MCQV2/QI2&MCQV Design Change Notification

MCQV2/QI2&MCQV standard cylinder will have following changes.

Accessory FAC/FBC

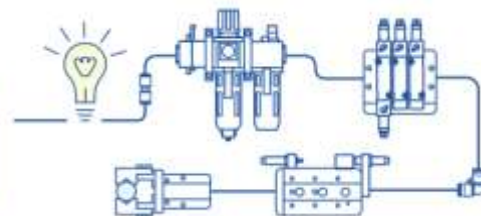
To reduce the weight.

口徑	FU	FX	口徑	FU	FX
Ø40	93	54	Ø40	90	52
Ø50	112	67	Ø50	110	65
Ø63	127	79	Ø63	125	76
Ø80	158	98	Ø80	154	94
Ø100	185	116	Ø100	180	112
Ø125	211	140	Ø125	210	140
Ø160	283	184	Ø160	280	180
